**STAFF RECOMMENDATION**

**413 N 16<sup>th</sup> Street**  
**September 16, 2020**

**Application:** New Construction—Addition  
**District:** Lockeland Springs-East End Neighborhood Conservation Zoning Overlay  
**Council District:** 06  
**Base Zoning:** R6  
**Map and Parcel Number:** 08310001600  
**Applicant:** John Root  
**Project Lead:** Paul Hoffman; [paul.hoffman@nashville.gov](mailto:paul.hoffman@nashville.gov)

Figure 5. The addition's connection to the historic ridge alters the historic roof form inappropriately.

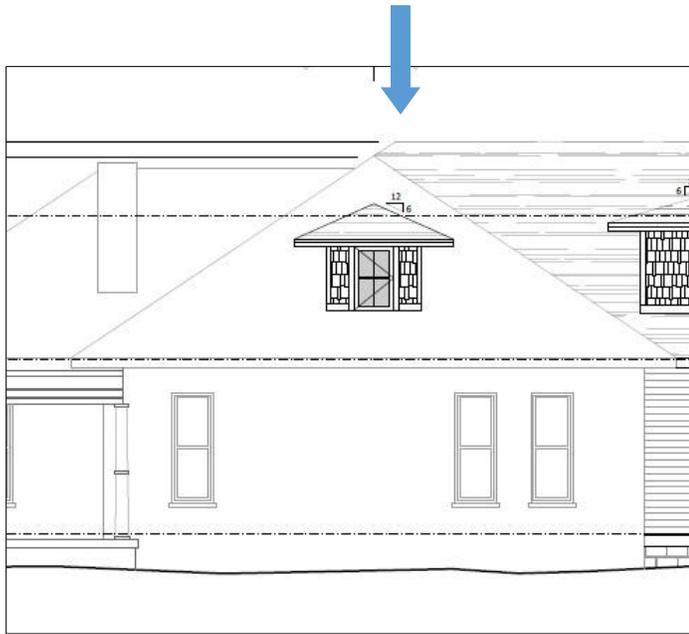
**Roof form:** The addition has a gabled roof with 8/12 pitch. It is connected to the existing hipped roof with a continuation of the hip upwards one foot (1') and requires removal of the majority of the left-rear, original, pyramidal, ridge line. As discussed in Height and Scale, the additional height could be appropriate, however staff finds the method of the connection to the addition to be inappropriate, as it changes the form of the roof and is not sufficiently differentiated from the roof of the historic building (Figure 5). The right side meets the design guidelines; however, the left side wipes out the existing ridgeline. In the past, the Commission has tried to retain the ridgelines as a way to maintain the original form and allow for an addition to be removed in the future, if original conditions were ever desired to be restored (II.B.10.d.). Section II.B.10 for additions states that additions that tie into the existing roof should do so at least six inches (6'') below the ridge line. Staff recommends that the addition's roof is revised for the addition to meet the ridge of the house at least six inches (6'') below each existing ridge.

1. The addition's roof form is revised for the addition to tie into the existing roof at least six inches (6") below the ridges;
2. The left side dormer is either removed or redesigned so that it sits on the new addition only;
3. The horizontal window on the addition's right side is redesigned to be at least two traditionally (2:1) proportioned windows; and,
4. Staff approve the final details, dimensions and materials of windows, doors and roofing color prior to purchase and installation.

Figure 7. The dormer stretching across the new and historic roof forms is not a compatible roof form.

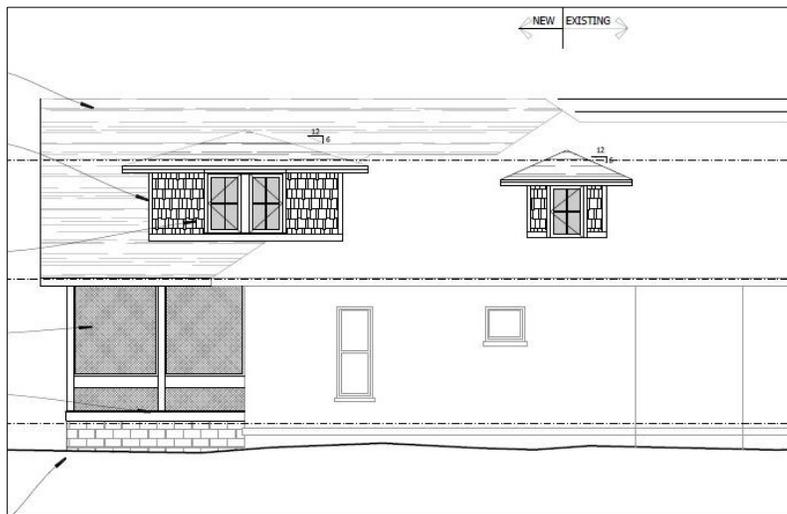
The sides of the addition also include fourteen foot and one inch (14' 1") wide dormers. Dormers on an addition may be larger than what is required for a historic building, depending on their scale and location. Typically, the front face of dormers should be primarily glazing, as seen historically. The right-side rear dormer's face is not primarily glazing; however, it is located in a minimally visible location. The dormer on the left side does not meet the design guidelines as it destroys the original roof form. Staff recommends that the dormer be redesigned so that it sits only on the roof of the rear addition in a manner that retains the original roof ridges.

Staff recommends the left side dormer be removed or redesigned so that it does not span both the old and new roof form.

Figure 8. Staff recommends this long horizontal window is broken up into at least two traditionally proportioned windows.

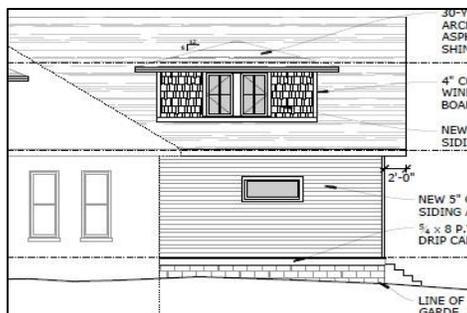
There are horizontal windows on the addition's right side (Figure 8) and on the rear that do not meet the historic window proportions. Although the side window is towards the rear of that façade, Section II.B.4 states that the window pattern should not contrast greatly with surrounding historic buildings. Because the location of the rear window will not impact the character of the house, as seen from the street, Staff finds it to meet the design guidelines. Staff recommends that the window on the right side of the addition is revised to be more compatible, with at least two traditionally proportioned windows. The horizontal window is likely desired because the interior use is a closet; however, windows with 2:1 proportion could be enclosed by shutters or could have opaque glass allowing the interior to be walled-over, if desired. With this condition, staff finds the project's proportion and rhythm of openings will meet Section II.B.7.
